DEVELOPMENT and PLANNING SERVICES COMMITTEE

March 5, 2018

Development Services Department Memorandum

Subject: Zoning Bylaw Amendment Application No. 1117

- Franklin Engineering Drawing 17-018 SK-01 Access Assessment Site Plan (Rev2)
- Sightline Photos

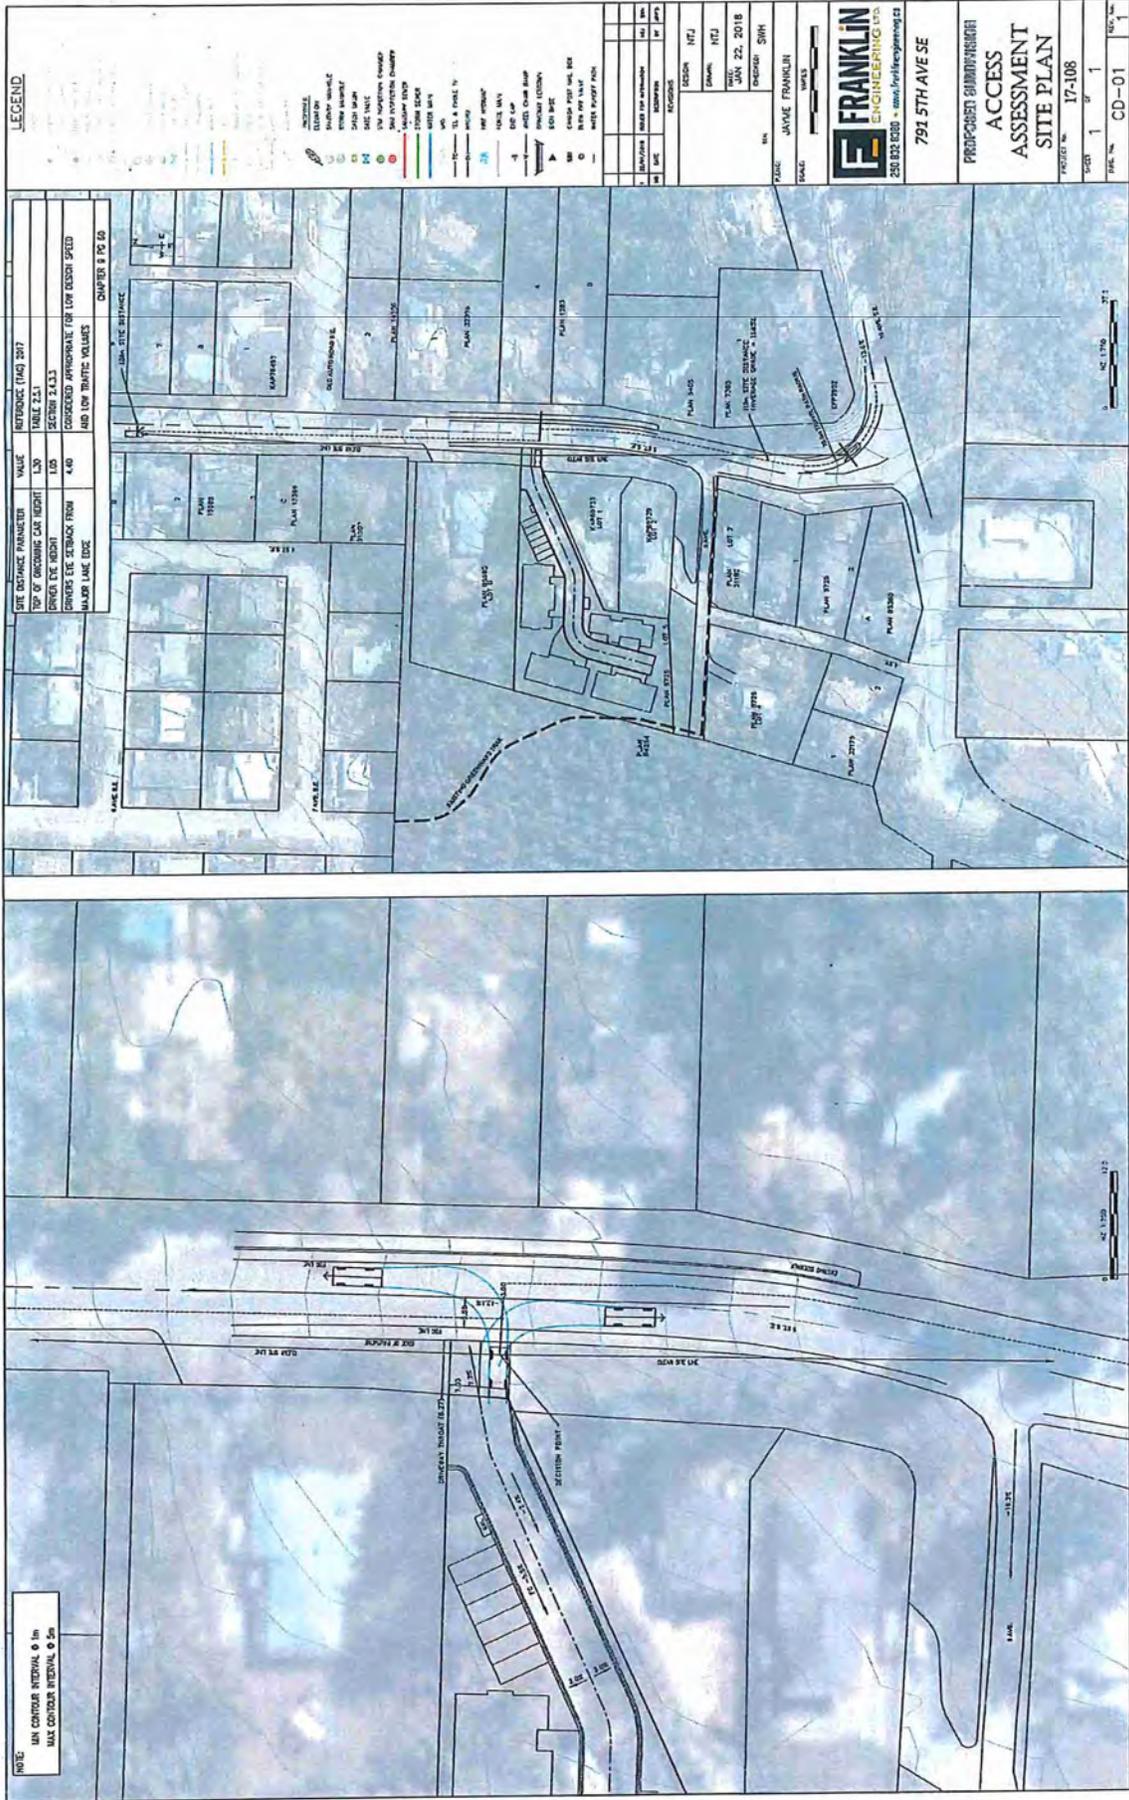
The driveway entrance should be upgraded to a width suitable to for two way access (>7.2m) and to provide a flat throat grade ($\pm 2\%$) to ensure a safe storage platform is provided for vehicles waiting to enter and exit the driveway.

The existing gradient of the driveway throat (first 5.0m) exceeds the recommended maximum grade. The provision of appropriate clear throat length or storage space is particularly important as it provides a flat storage platform for vehicles waiting to enter the live lane and for receiving vehicles leaving the live road. The driveway should be upgraded to provide a flat ($\pm 2\%$) platform at the entrance/exit.

3. The internal driveway access should be of a suitable width, or provide a suitable turning area to allow passenger vehicles to exit the driveway in a forwards direction. Ie prevent vehicles from exiting driveway in reverse.

2. The driveway entrance should be upgraded to a width suitable to for two way access (>7.2m) and to provide a flat throat grade ($\pm 2\%$) to ensure a safe storage platform is provided for vehicles waiting to enter and exit the driveway;

Figure 1: Sightline from Decision Point Looking North

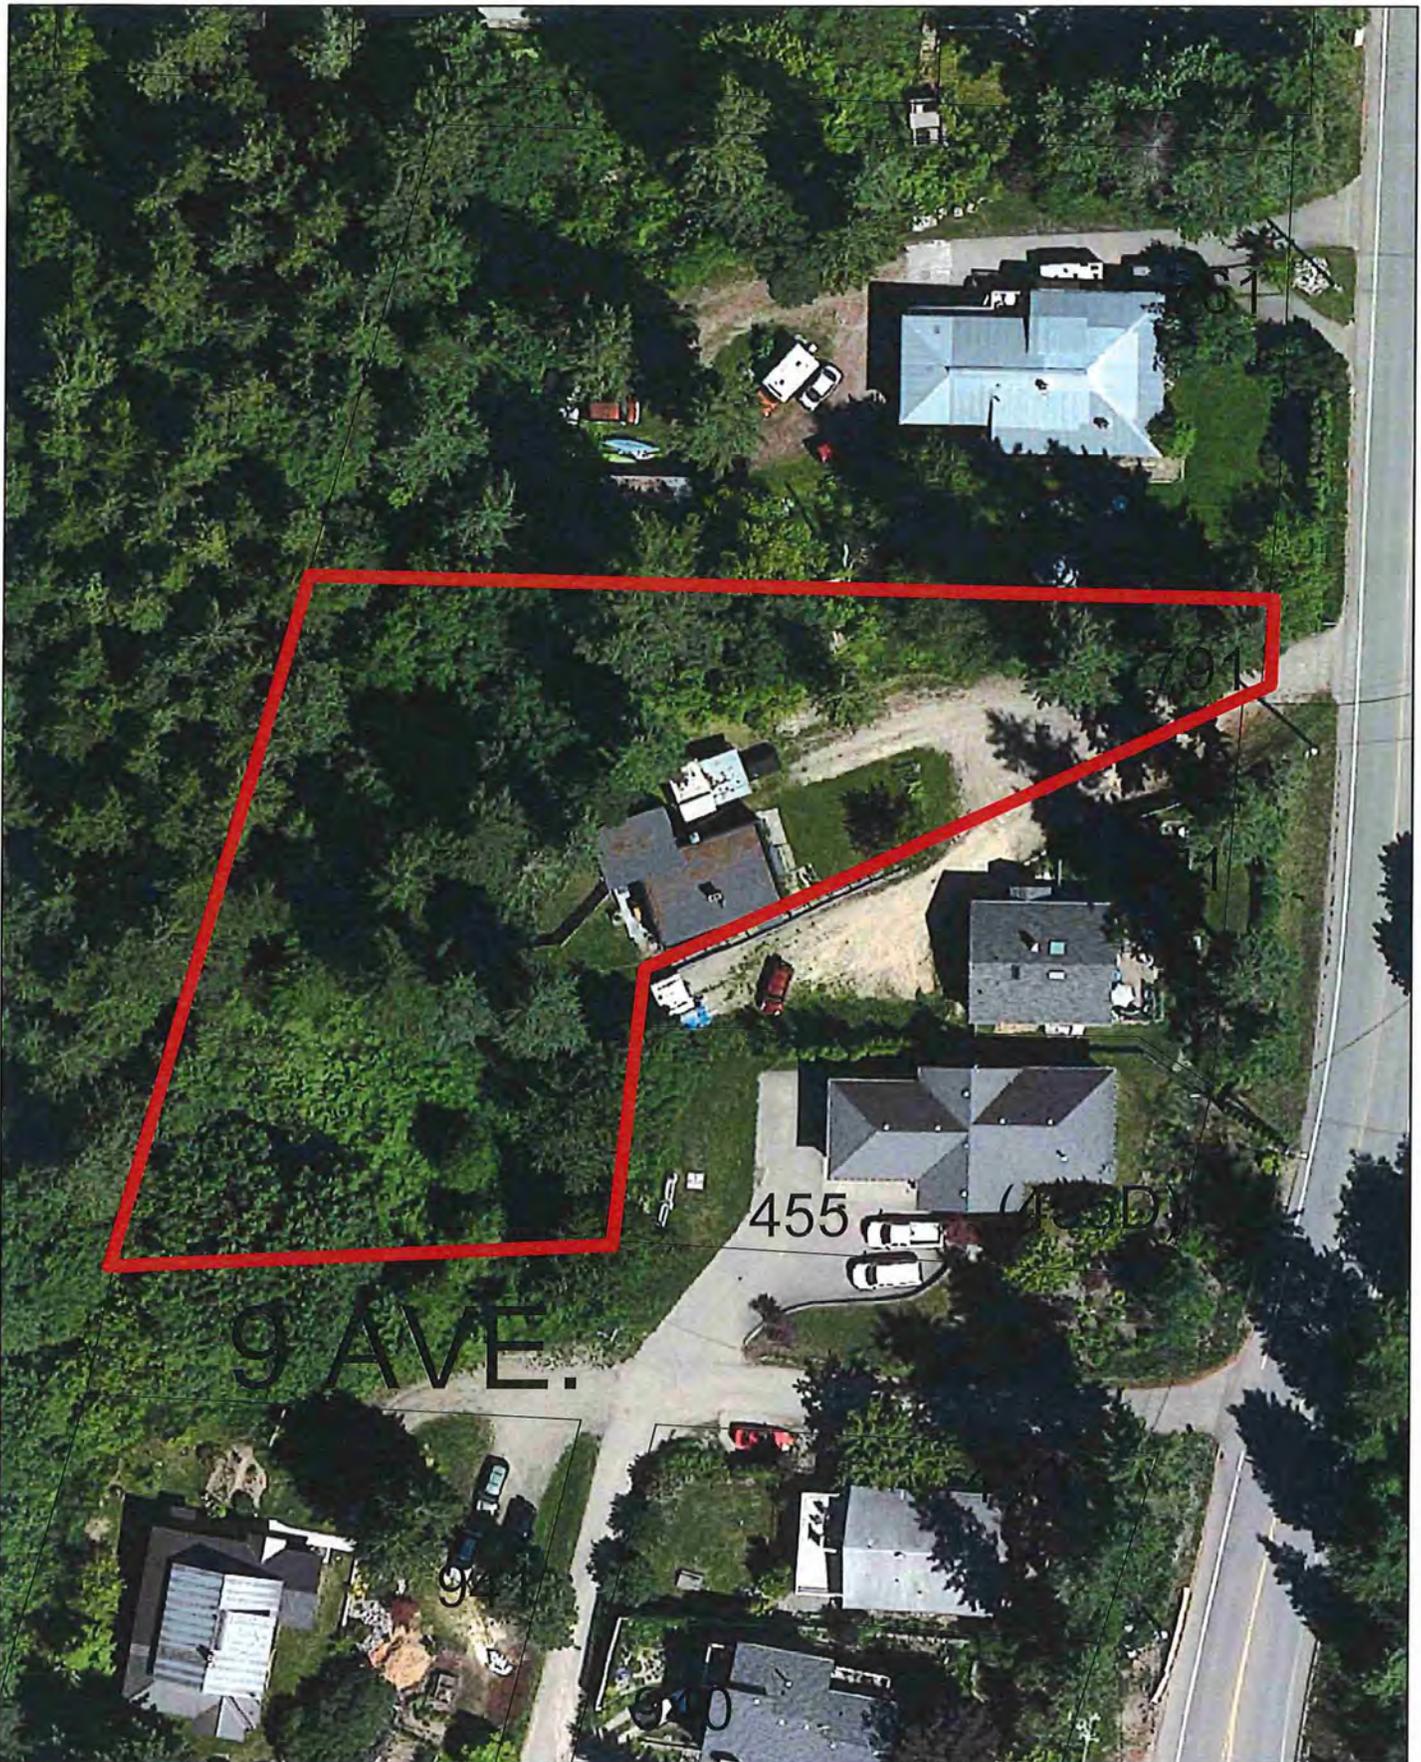
Looking north down 5th St SE, sightlines are clear and in excess of 120m. Minor trimming of the adjacent hedges (to the south) should be undertaken regularly to ensure the sightline remains clear and unobstructed.

5. Minor trimming or removal of the adjacent trees (to the south) should be undertaken regularly to ensure the sightlines remains clear and unobstructed.

Figure 2: Sightline from Decision Point Looking South

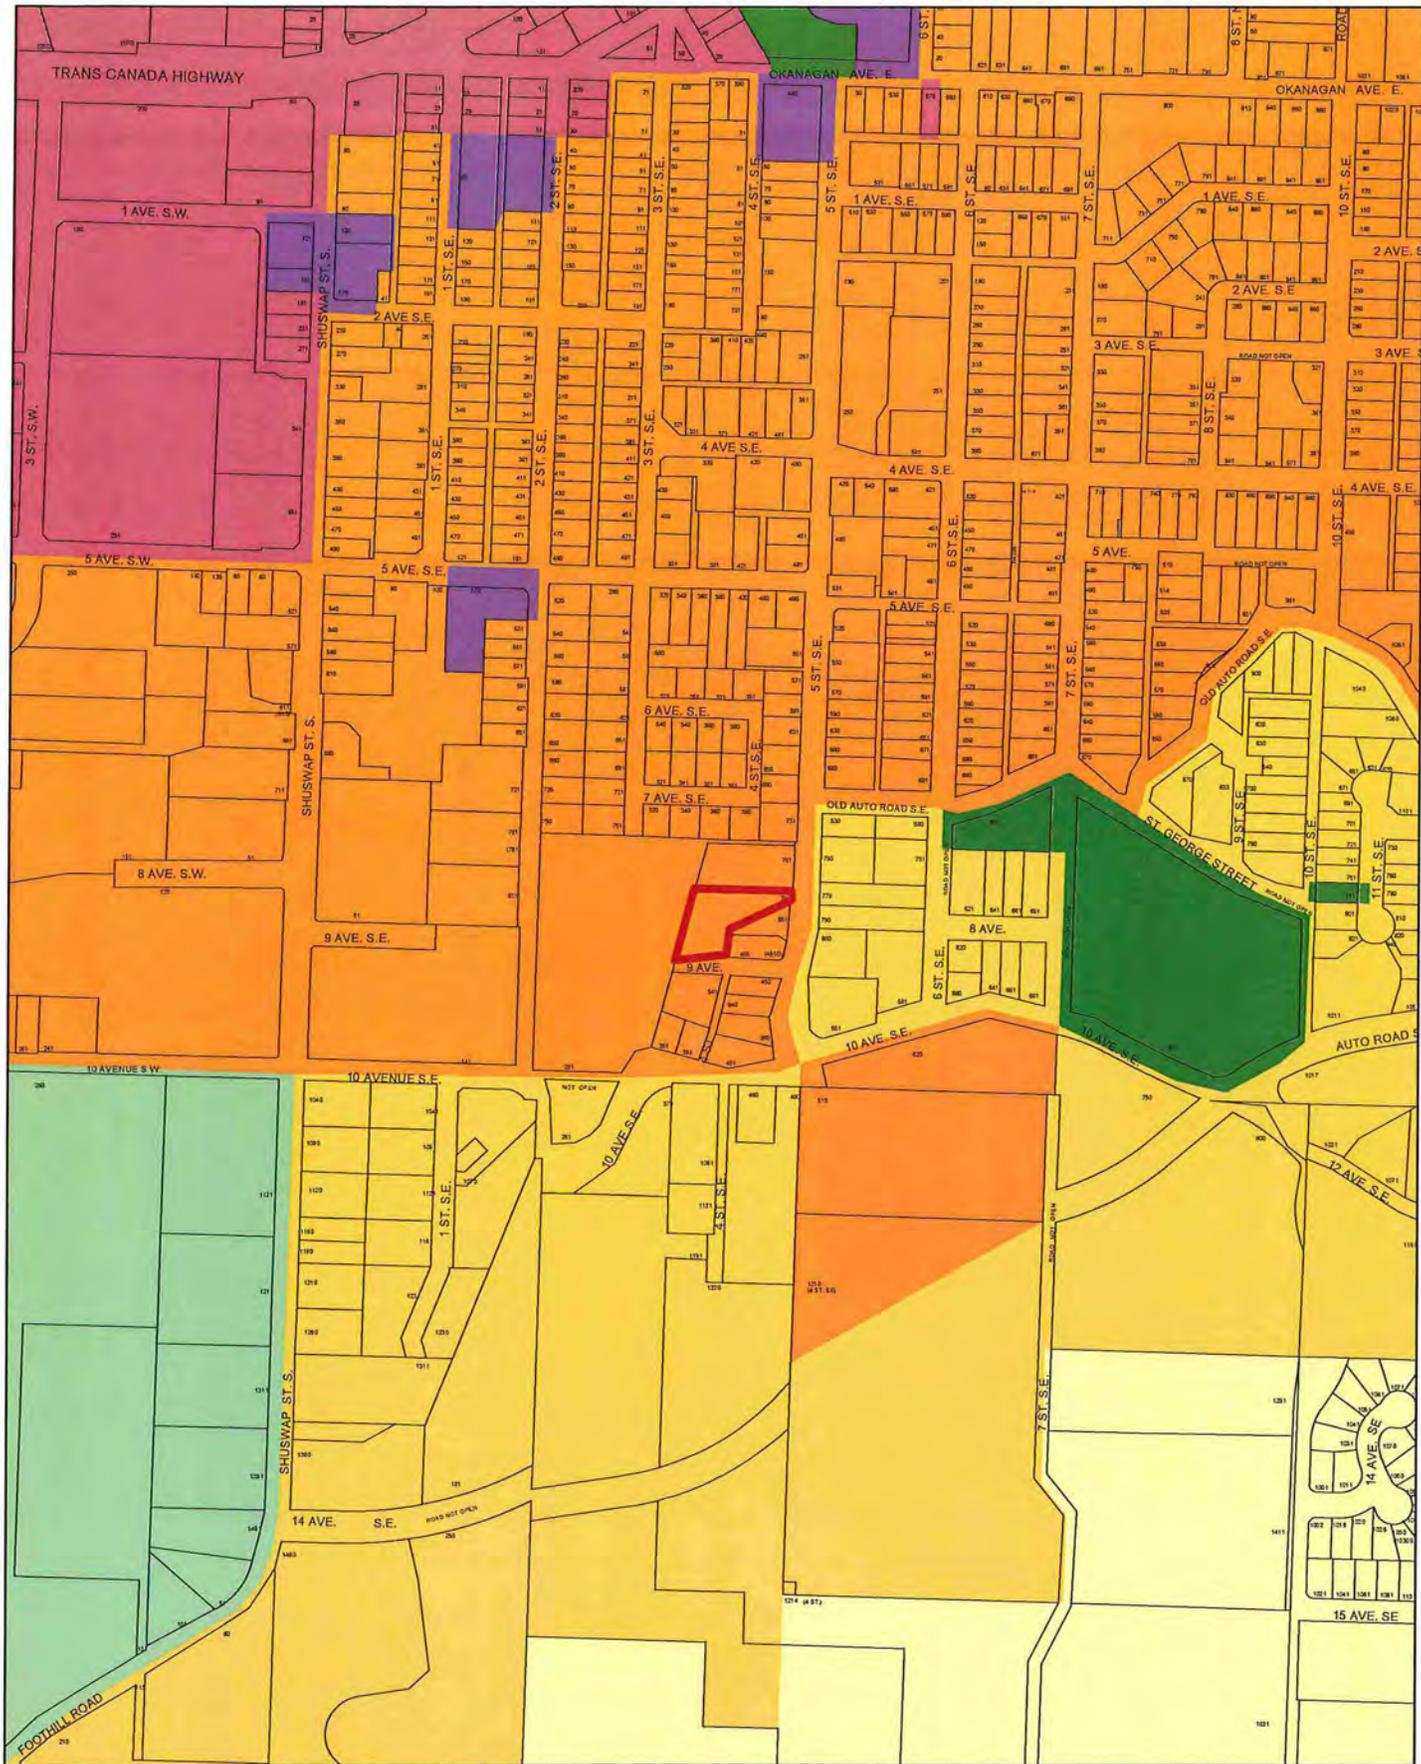
Looking south towards the 10th Ave SE intersection, sightlines allow view of cars entering 5th St SE from 10th Ave SE. A revised design speed of 30km/hr has been calculated for northbound vehicles based on a reduced travel speed for vehicles that have just navigated the 5th St/10th Ave intersection corner (calculated using a 23m curve radius and field verified). Using this travel speed, the available sightline (110m) exceeds the minimum requirements (80m) including an adjustment for the road gradient.
